Date of Issue: March 2013

Affected Publication: API Specification 6A, *Specification for Wellhead and Christmas Tree Equipment*, Twentieth Edition, October 2010

ADDENDUM 3

*Replace **Annex O** in its entirety with the following pages.*

Figure 3 c)

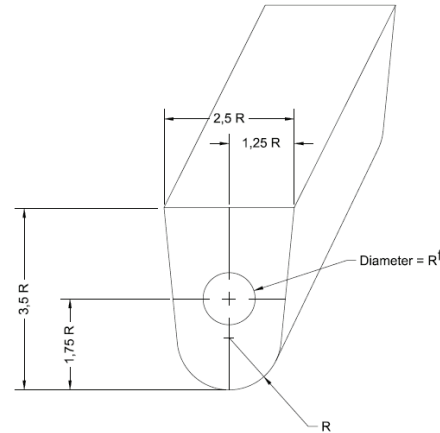
c) Keel block configuration, ER equals 2,3R

Figure 3, footnote f

Replace footnote f with:

^f This area is the centre core $1/4T$ envelope for test specimen removal.”

Figure 6 — Hardness test locations for weld overlays

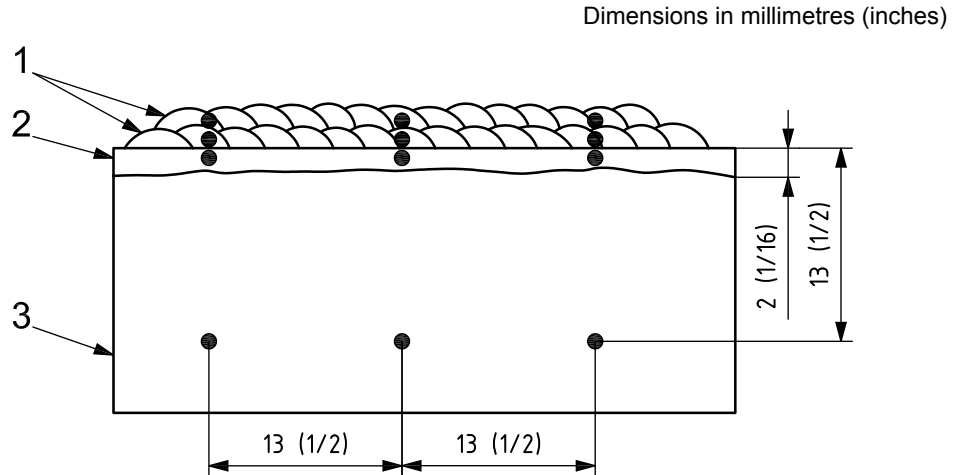
Welds for use in hydrogen sulfide service shall conform to the requirements of ISO 15156 (all parts) (NACE MR0175; see Clause 2). If the welding procedure is to be qualified for use on bodies, bonnets or flanges used for material classes DD, EE, FF or HH, hardness testing shall be carried out by the Rockwell method in accordance with ISO 6508 (all parts) or ASTM E18, or the Vickers 98 N method in accordance with ISO 6507 (all parts) or the Vickers 10 kgf method in accordance with ASTM E92. Hardness tests shall be performed at a minimum of three test locations in each of the base material, the heat-affected zone and in each layer of overlay up to a maximum of two layers. See Figure 6 for required hardness test locations.
